CITY OF LA VISTA
MAYOR AND CITY COUNCIL REPORT
OCTOBER 15, 2019 AGENDA

Subject:	Type:	Submitted By:
APPLICATION FOR PUD SITE PLAN – LOTS 19-20, SOUTHPORT WEST & LOTS 2-3 SOUTHPORT WEST REPLAT 2 (NW OF WESTPORT PKWY)	◆ RESOLUTION ORDINANCE RECEIVE/FILE	CHRISTOPHER SOLBERG SENIOR PLANNER

CASE NUMBER: PPUD-19-0001

RE: Planned Unit Development (PUD) Amendment
Initial Review
Brixmor North – Southport West

EMERGENCY VEHICLE ACCESS PLAN		NO.	DATE	REVISED DESCRIPTION
PUD PLANS				
BRIXMOR NORTH LOTS 2, 3 19, 20			2019	REVISIONS
LA VISTA, NEBRASKA				
Drawn by:	JLC			
Checked by:	EW			
Approved by:	-			
VQC by:	-			
Project no.:	019-1124			
Drawing no.:				
Date:	06.03.19			
SHEET C5.1

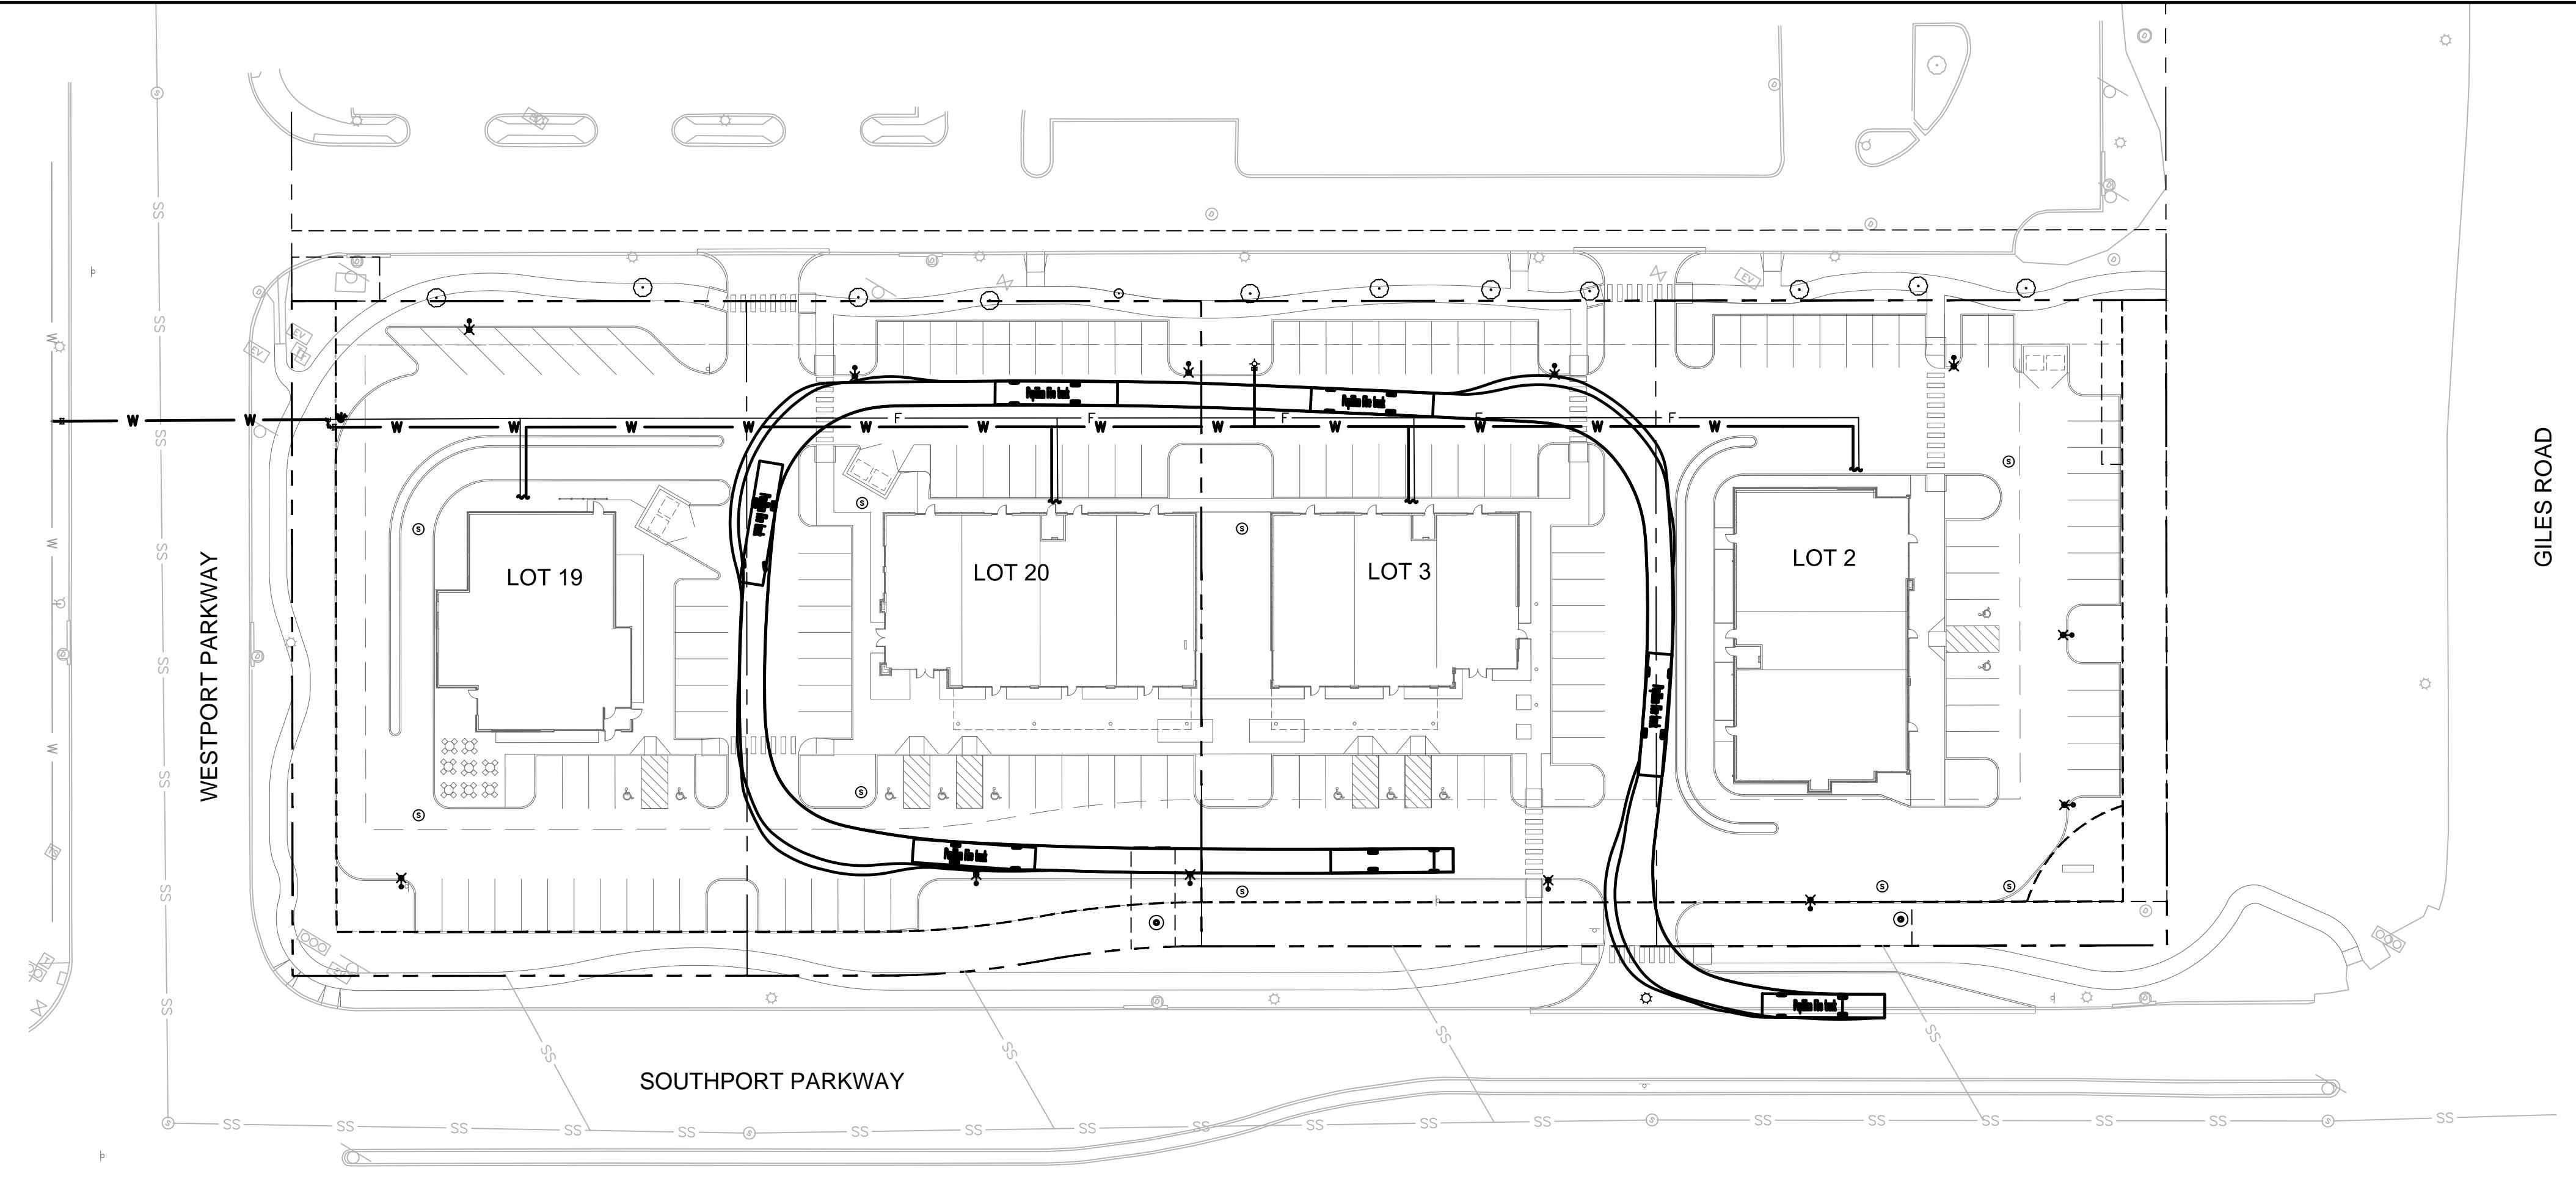
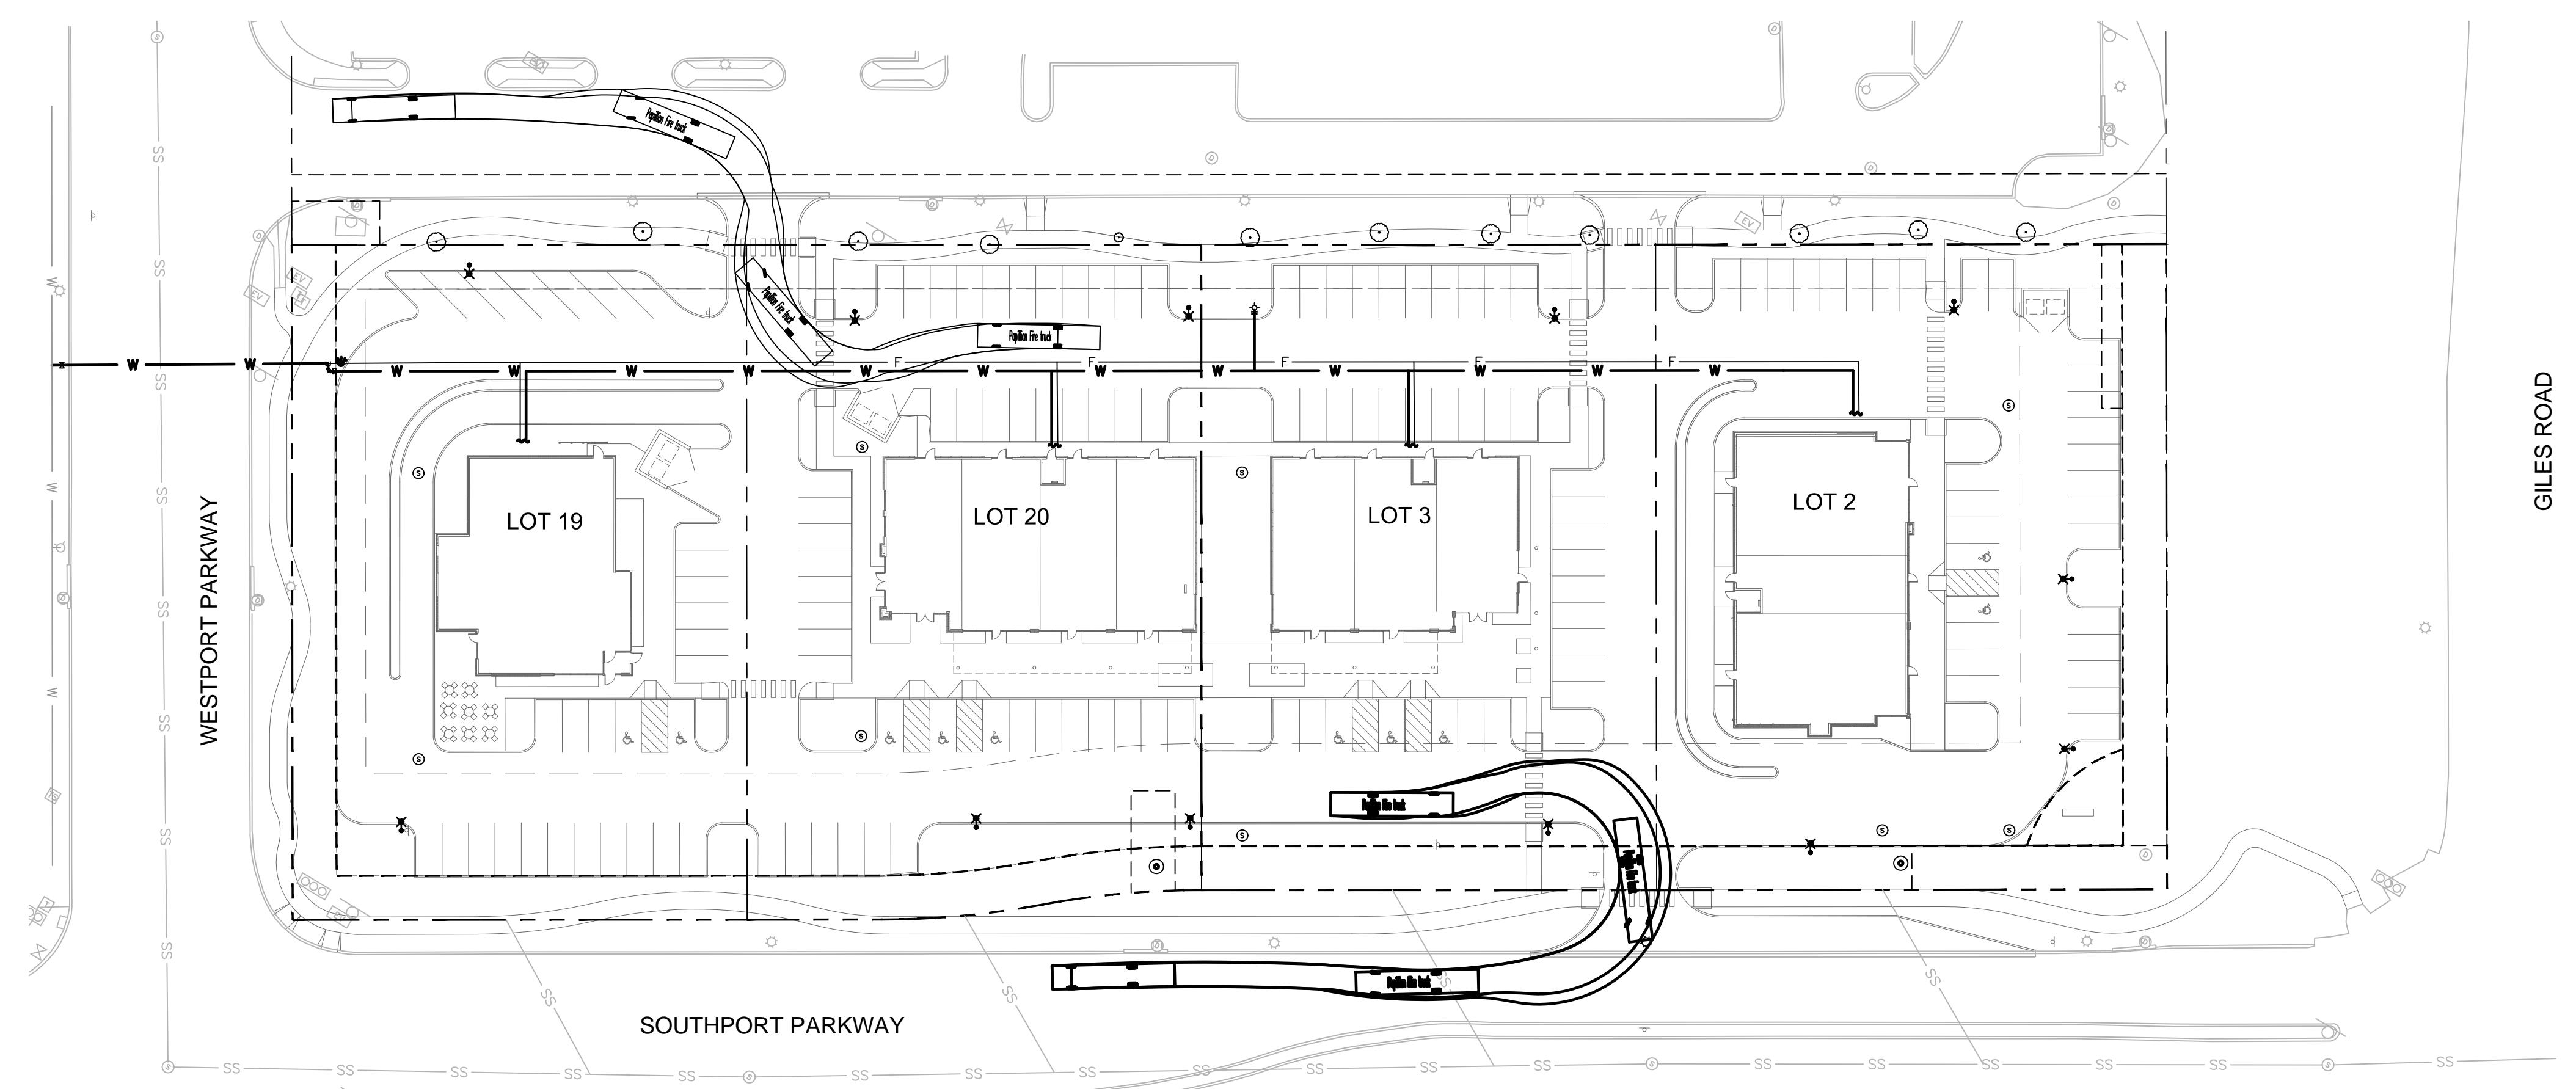
- The Fire Marshall requests to see how trucks can maneuver throughout the site, not just between the entrances to the development.

- In the Emergency Vehicle Access Plan, the proper apparatus turning radii and proper vehicle size were not used. The proper apparatus, provided by the Fire Marshall, is attached. Please adjust the turns and display the proper basis/legend in the top-right corner.

Response: Routing has been updated through the site.

Figure 2. Existing Traffic Volumes

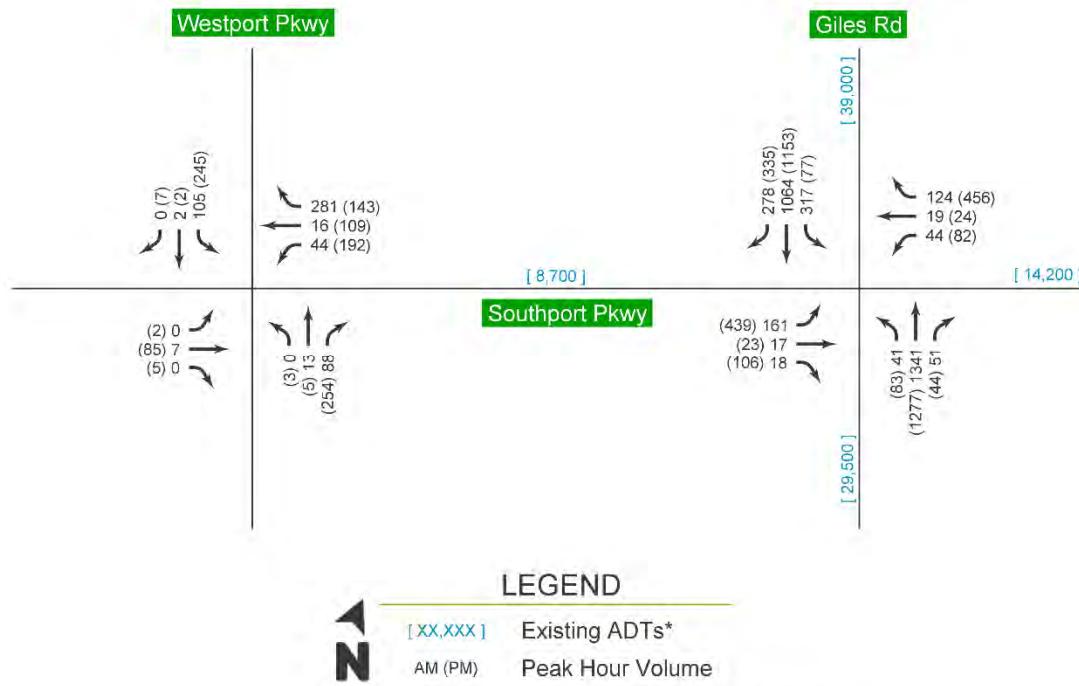
- Please note the source of Existing ADT values in Figure 2 of the study.
- Please provide total driveway volumes when considering both primary and pass-by trips.
- Trip distribution does not appear to fully take into account pass by trips to destinations within Southport development. Is there a standard methodology that is being used to apply the distribution percentages as applicable adjacent land uses/trip generators?

- Please note the source of Existing ADT values in Figure 2 of the study **Response:**
- Please provide total driveway volumes when considering both primary and pass-by trips. **Response:**
- AM signal timings should be reviewed to make recommendations as to any pertinent modifications **Response:**
- Applicant should install all access and signage improvements as recommended in Section 7 of the Traffic Impact Study **Response:**
